Subject ▶ Change on rubber ring 26, etc.

For Models ▶ 1805B, 1806B (Power Planer), 4110B, 4110C (Angle Cutter)

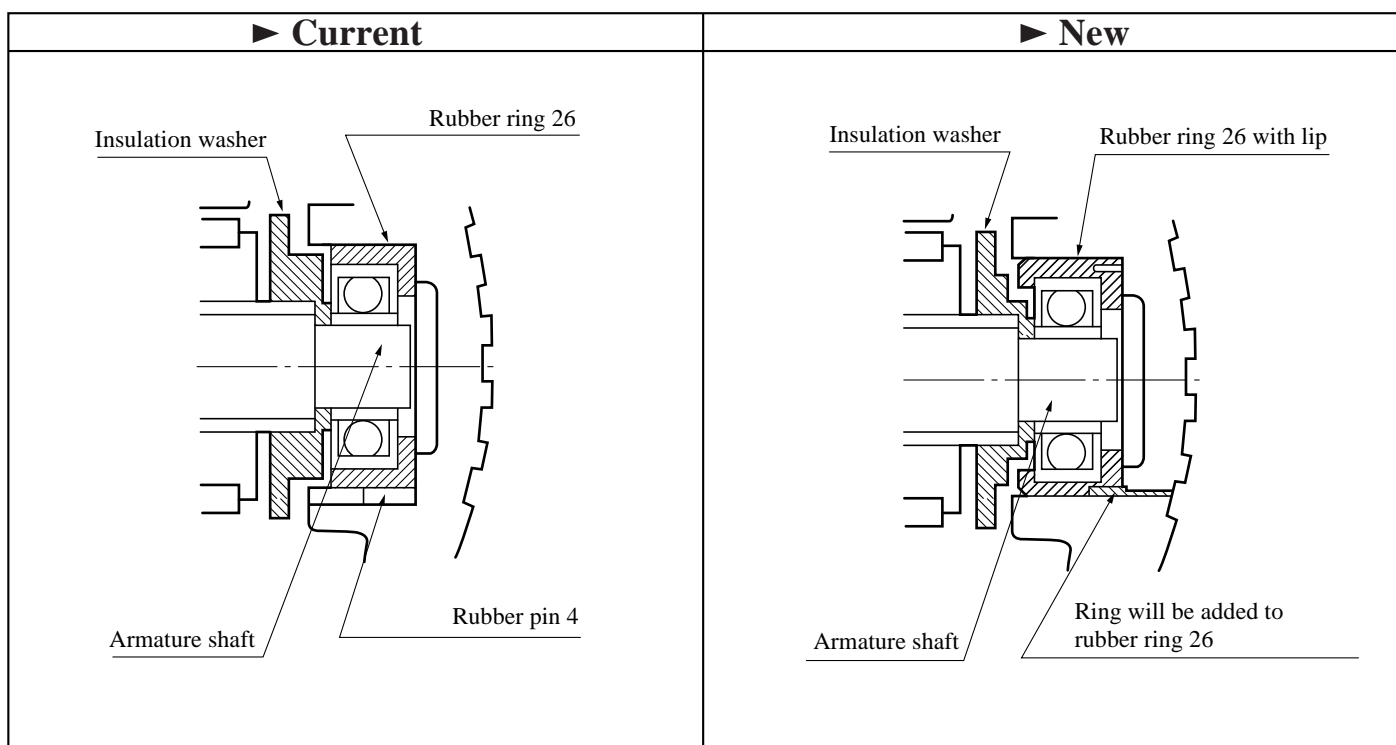
Description ▶ 1. The rubber ring 26 will be changed in material and shape as follows.
And a ring will be added to the rubber ring 26 as shown in the figure below.

Current	New
Material	Chloropren	Nitrile
Shape	Without lip	With lip

2. The insulation washer will be changed in shape as shown in the figure below.

The rubber pin 4 (a constituent part of motor housing) will be discontinued.

Item No.	Current part		Q'ty	I/C	New part		Q'ty	Note
64	Rubber ring 26 421417-8		1	=>	Rubber ring 26 421490-8		1	
22	Insulation washer 681624-7		1	<=	Insulation washer 681635-2		1	
65	Motor housing 156738-6		1	No	Motor housing 159687-6		1	For 4110B and 4110C
